Recall Bulletin :

NO. 21V-515

Xtreme Outdoors 2021 MyPod

Incorrect Mount Size

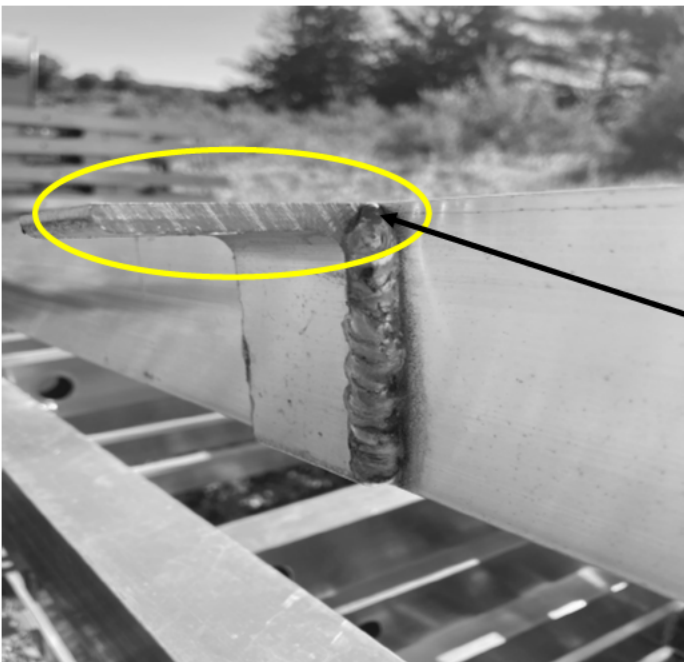
This 1/8" L-bracket is the incorrect thickness not to the original design of this model.

Please take photos of one or more of these mounting brackets and submit them in an email to Recall@goxtoutdoors.com You can also take your unit to your selling dealer to have this bulletin completed. Dealers can submit a claim for the allotted time if a customer wants a dealer inspection.

Correct Mount thickness

This L-bracket support mount is the correct thickness at 3/16". Please confirm your unit has this mount.
